**SUPERIOR CHARTER TOWNSHIP PLANNING COMMISSION
SUPERIOR TOWNSHIP HALL
3040 N. PROSPECT, SUPERIOR TOWNSHIP, MI 48198
AGENDA
FEBRUARY 26, 2025 - 7:00 PM**

STPC #25-02 Conditional Use Permit/Preliminary Site Plan - DTE Electric to expand the existing Grenada Electric Substation

DTE Electric Company is seeking approval for a combined Conditional Use Permit and Preliminary Site Plan to expand an existing electrical substation on a 3.76 acres parcel (J -10-18-261-012) located on the east side of Dixboro Road, south of Plymouth Road (see Figure 1). The property is in an Urban Residential District zoned R-4 (Single-Family Residential). The proposed new Grenada Substation would be classified as a "Utility Transmission and Distribution Lines and Pipelines not in Existing Easements or Rights-of-Way" and requires a Conditional Use Permit approval in an R-4 (Urban Residential District).

SITE PLAN

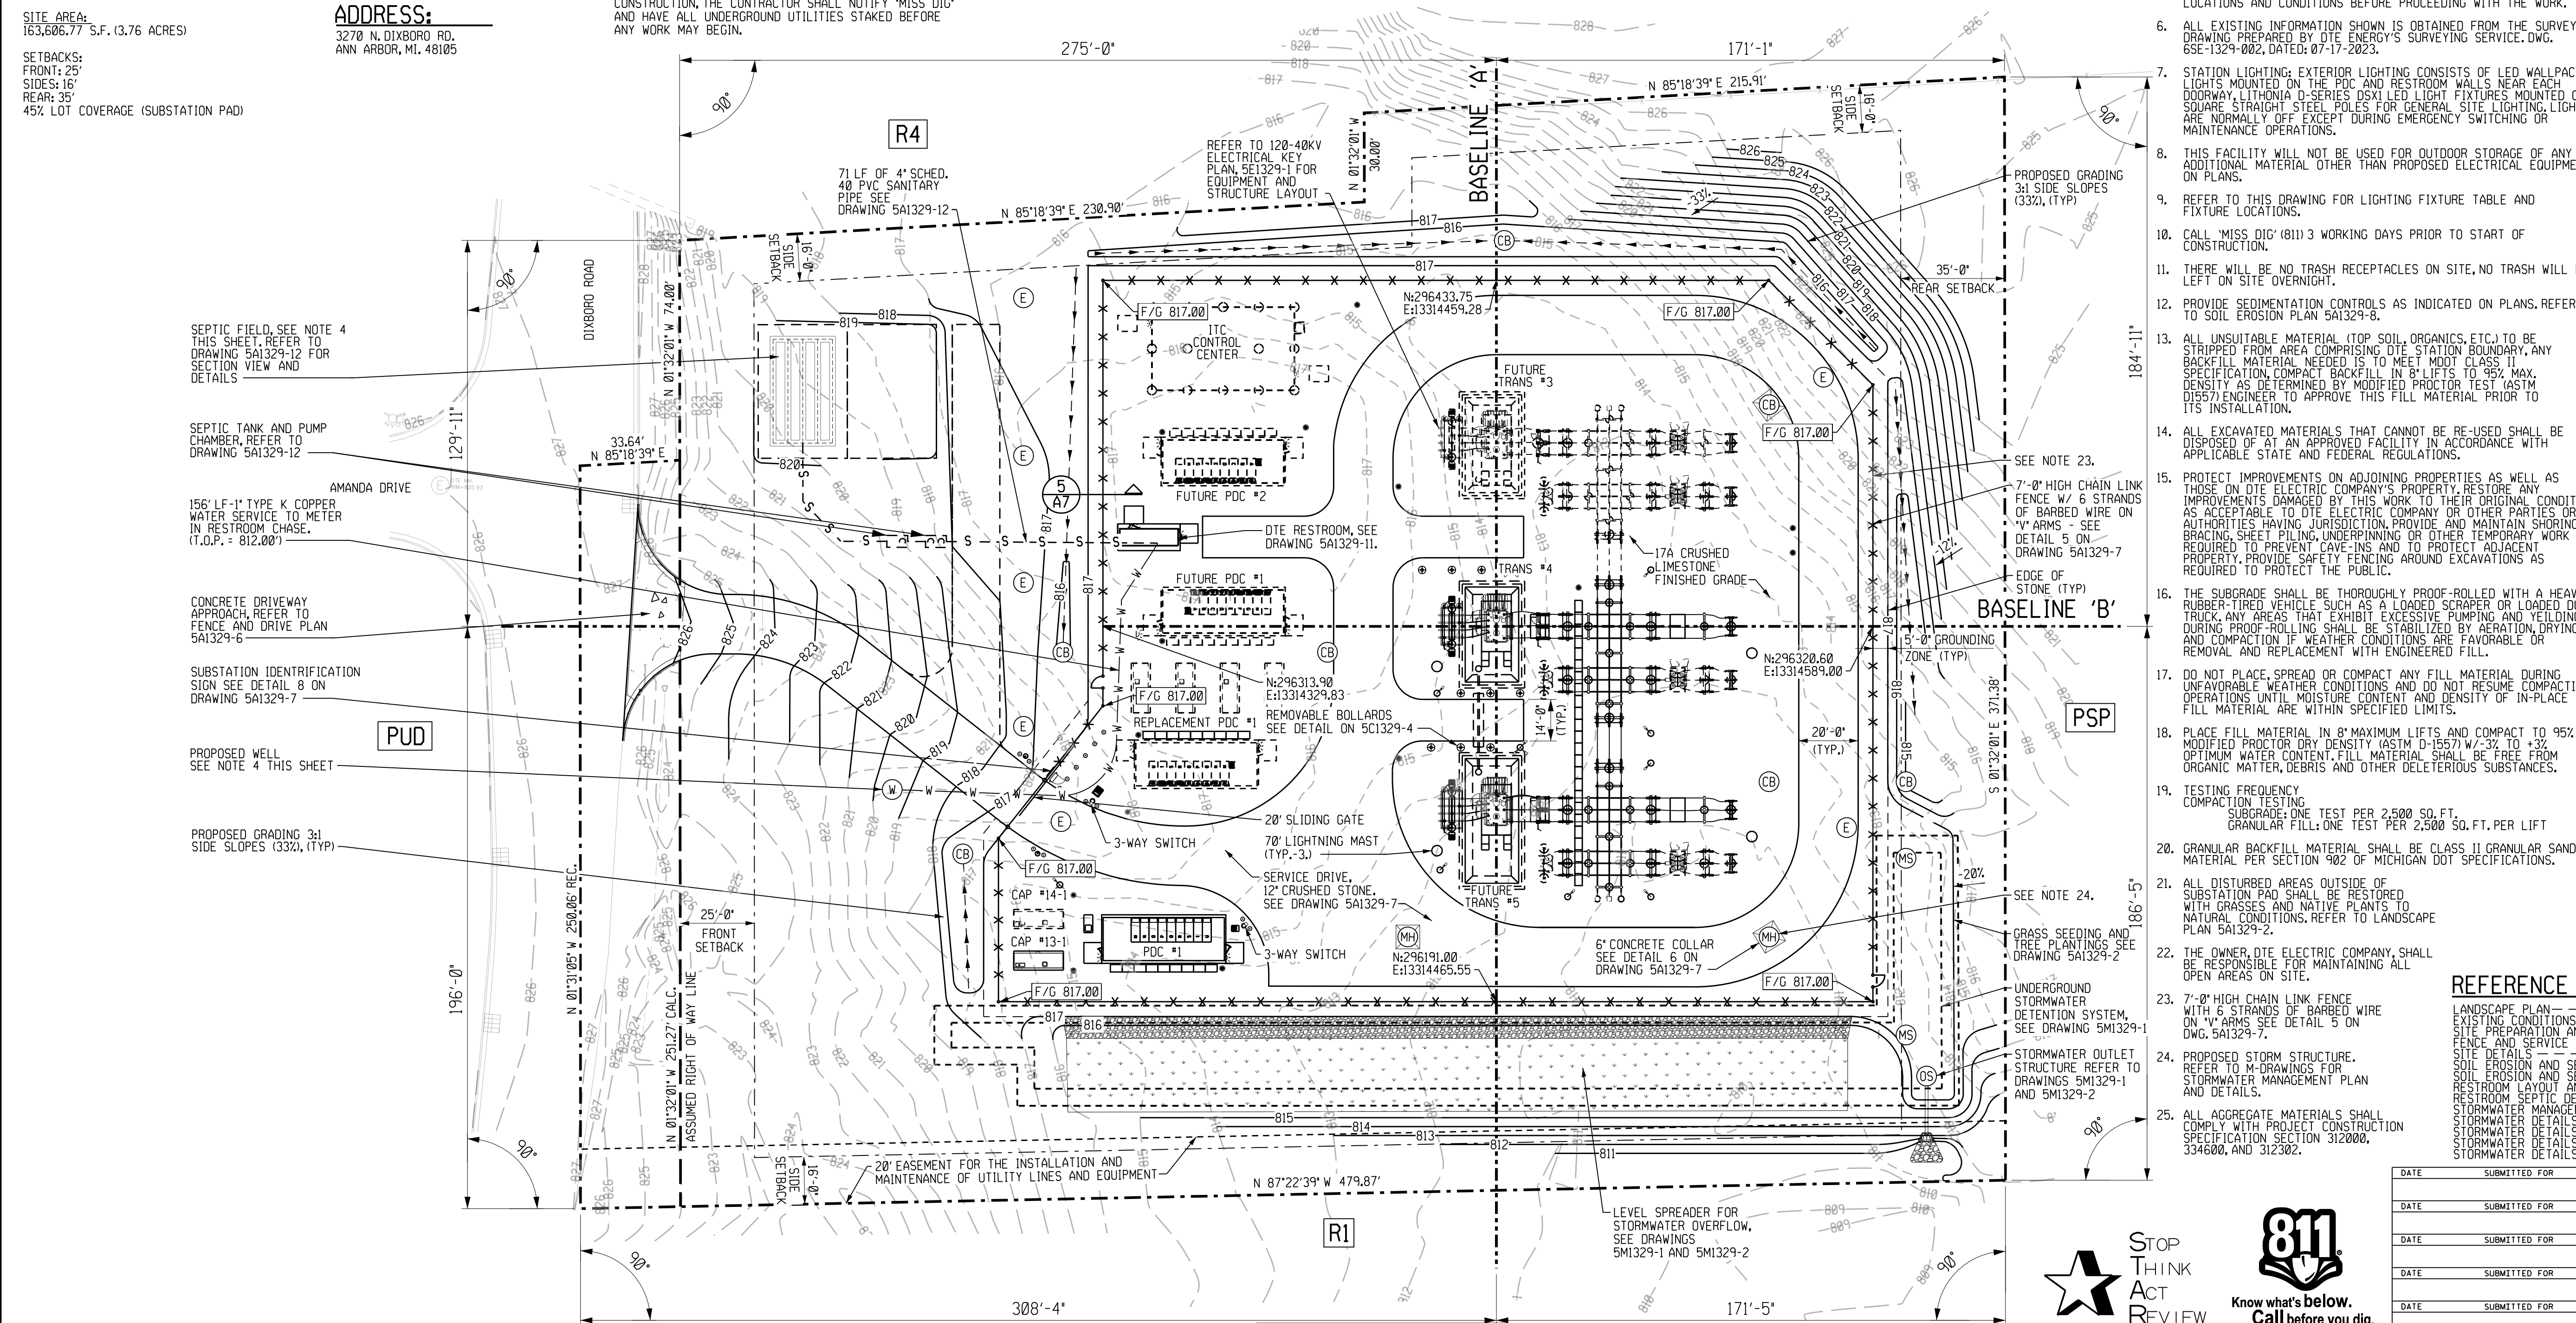
Sheet 5A1329-1 (Site Plan) includes zoning information for abutting properties. Abutting property near the northeast corner of the site is zoned Village Center (VC) and needs to be reflected on the plans.

Items to be Addressed: (1) Correct Sheet 5A1329-1 (Site Plan) to reflect that abutting property near the northeast corner of the site is zoned Village Center (VC).

Items to be Addressed: (1) Add note to plans that describe project phasing if any; (2) Provide more descriptive labels for PDC equipment enclosures on Sheet 5A1329-1 (Site Plan) it is not clear how many are proposed in total; (3) Clarify and correct, if necessary, the Lot Coverage calculation included on cover sheet under “Structure Summary” and under “Site Information” on sheet 5A1329-1; (4) Add details for “exterior electrical equipment” on cover sheet under “Structure Summary” including the height of all structures; (5) Calculate the Ground Floor Coverage (GFC) and Floor Area Ratio (FAR) and add notes to cover sheet; (6) Add fence details to the plans; and (7) Provide details on the need for the restroom.

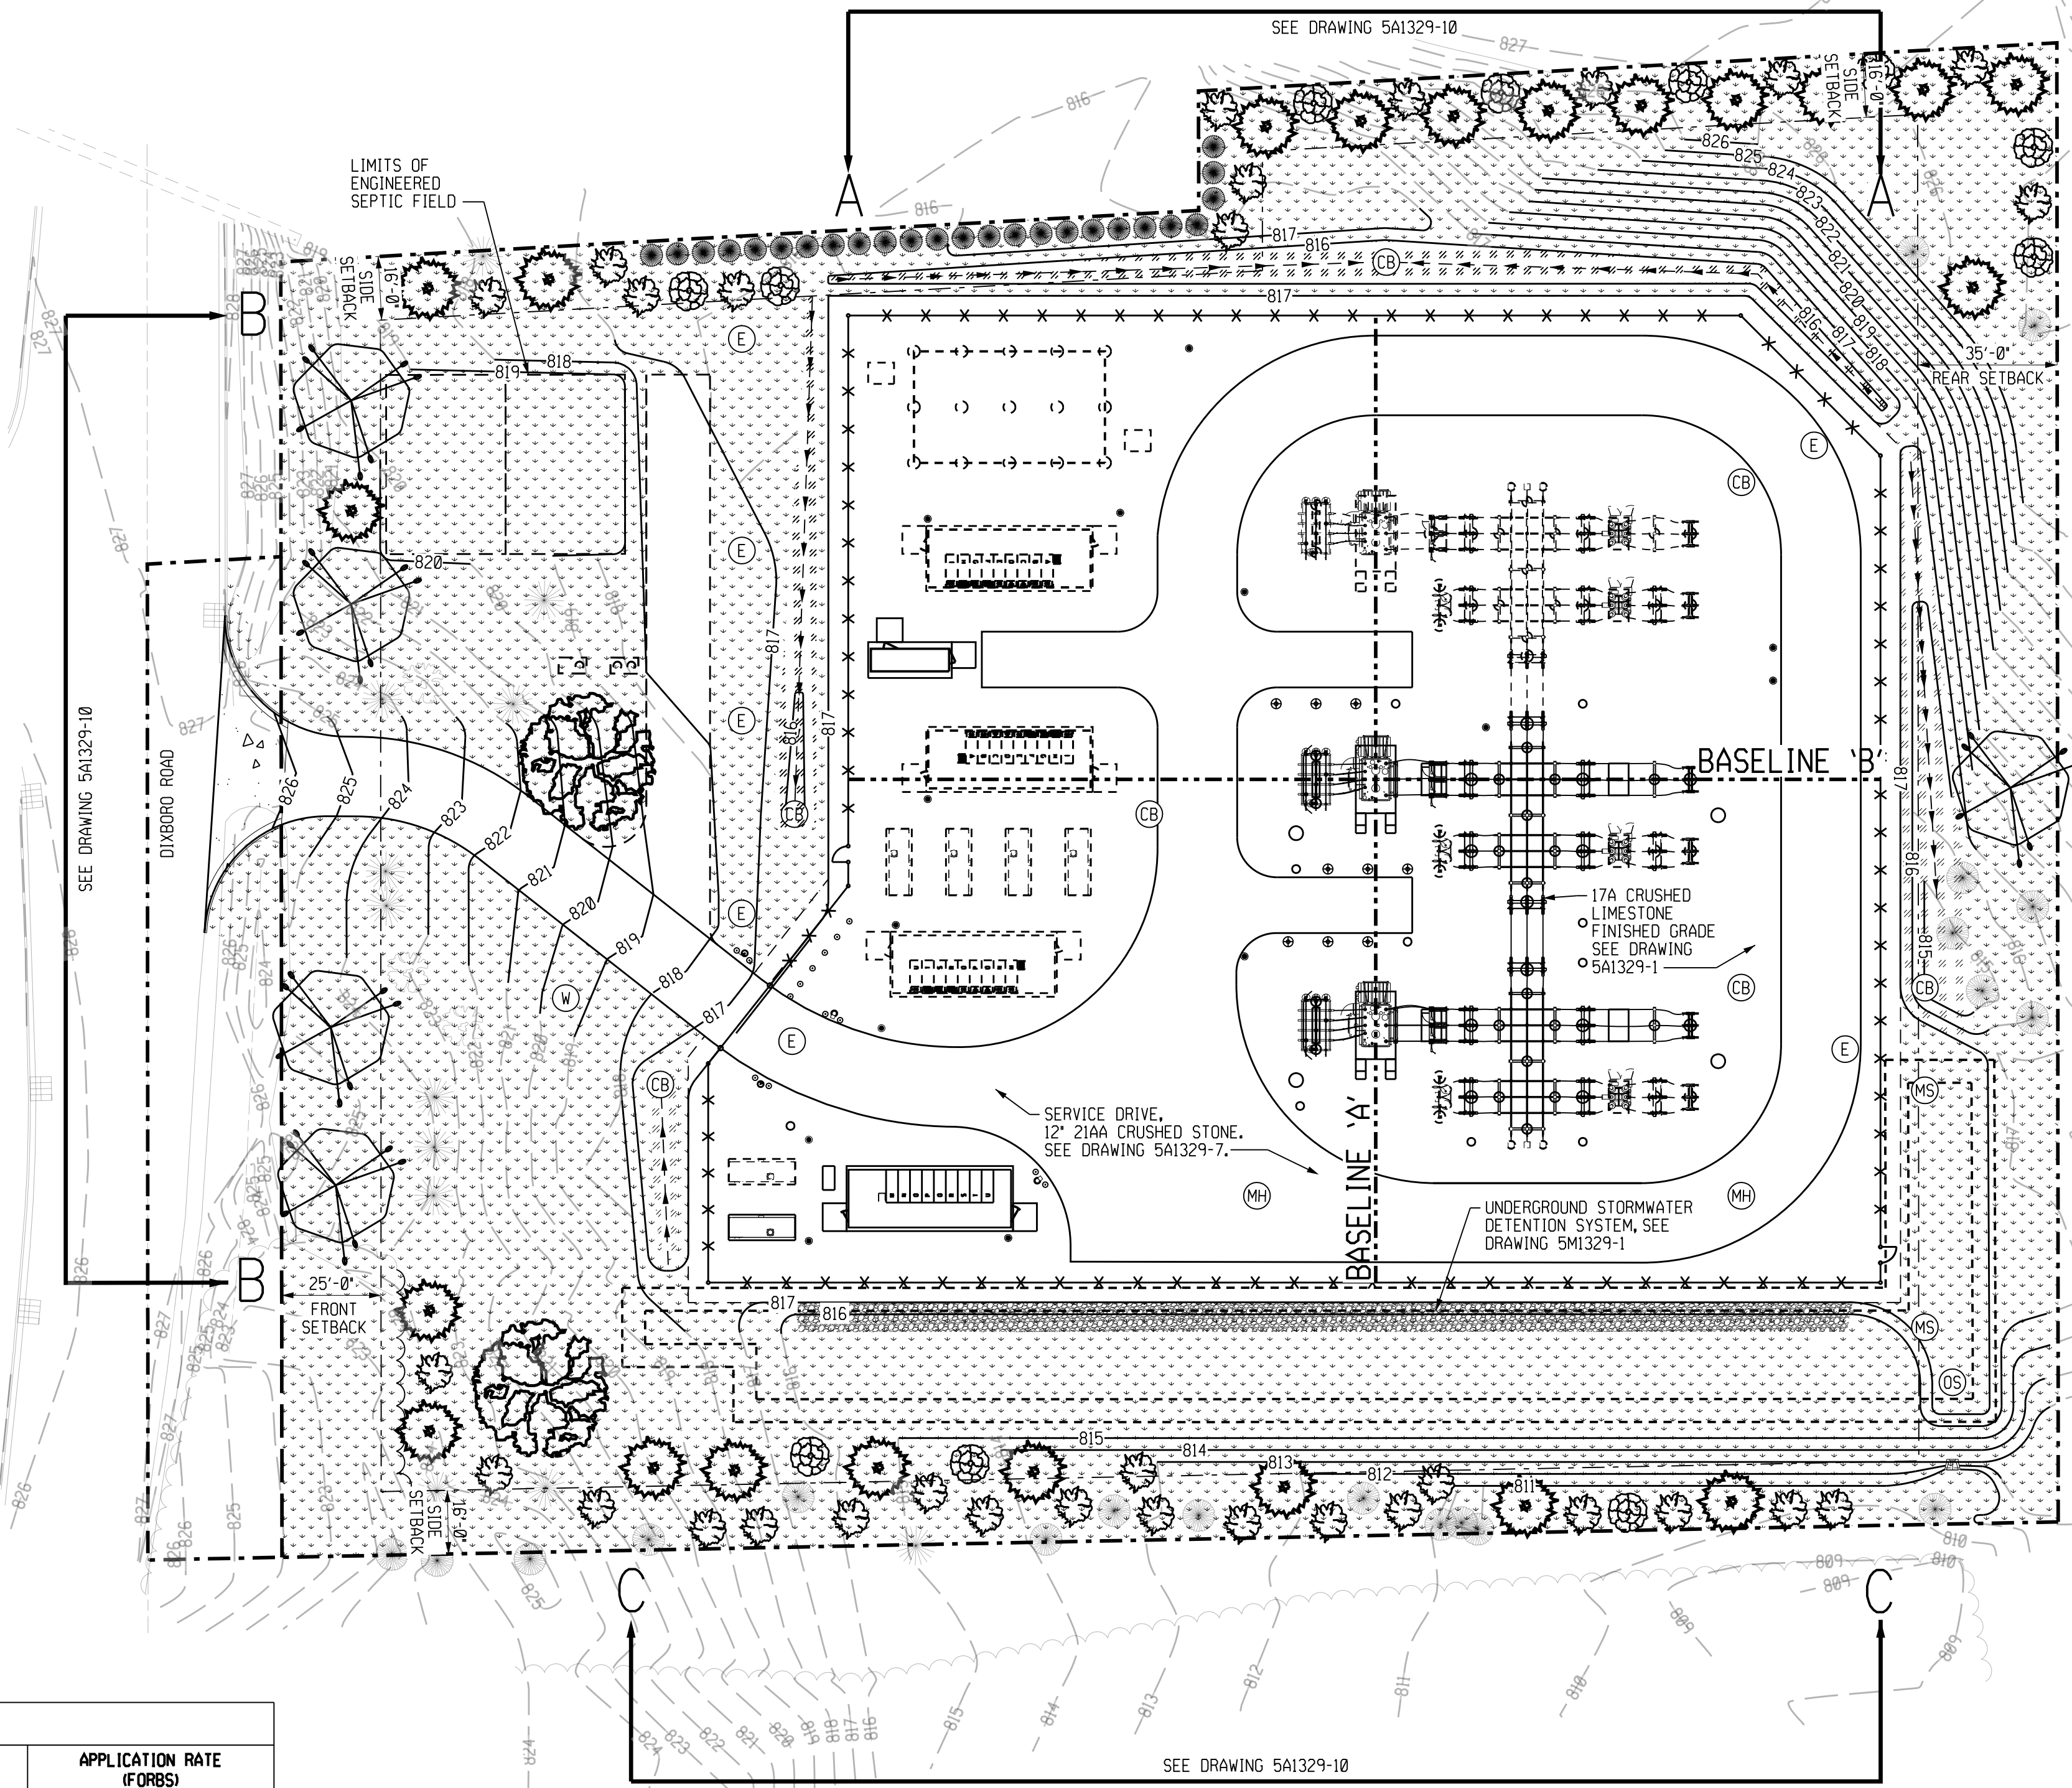
1. Site plans should bear the professional seals of an engineer and land surveyor licensed in the State of Michigan.
2. On Sheet 5A1329-2, Landscape Note 6 mentions an “ITC 90’-0” Transmission Easement east of the substation” that does not appear to be shown on the plans. The location and limits of this easement should be indicated on the plans.
3. Plans should include the initial plan date and any revision date(s).

5 YARD EDGE DETAIL
A6 NOT TO SCALE

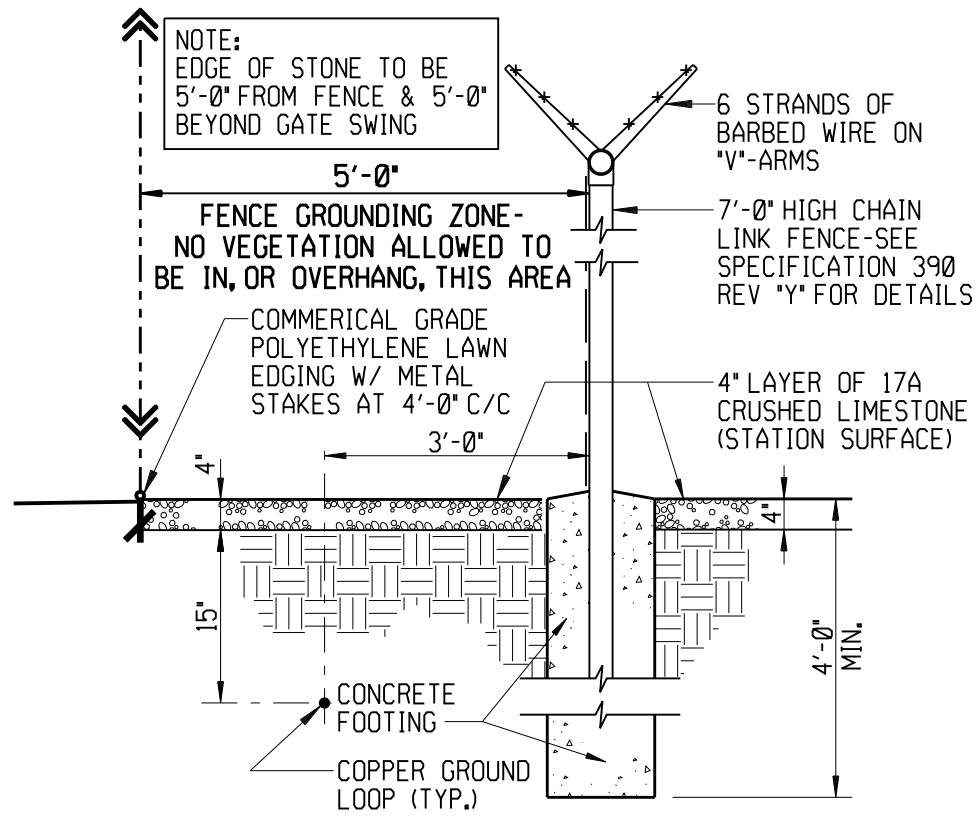
Sheets 5A1329-1 and 5A1329-6 have notes that reference a 7.0 ft high chain link fence with 6 strands of barbed wire on 'V' arms and calls out "Detail 5 on drawing 5A1329-7". Detail 5 shows aspects of the fence, but it is a "Yard Edge Detail" and calls out specification 390 rev "Y". Furthermore, general note #11 on sheet 5A1329-6 refers to another project construction specification for chain link fences and gates (e.g., 323100). These references need to be corrected, and the fence detail added to the plans.
